ADA Curb Ramp New Construction Inspection Form (Perpendicular)

Nw 287 ave

24952.54

Nw Shaddon st

PERPENDICULAR RAMP (PR)

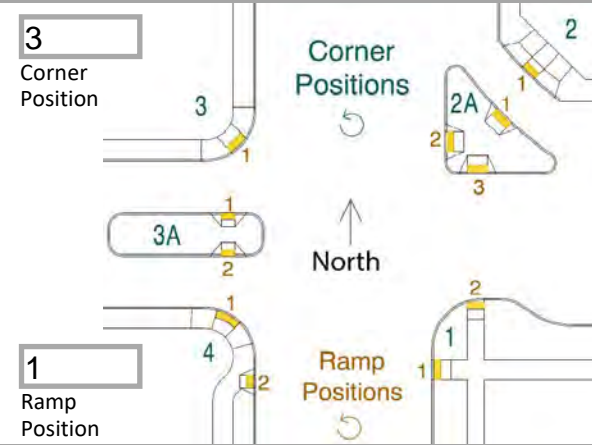
RR1 ICRR jbox in turn space
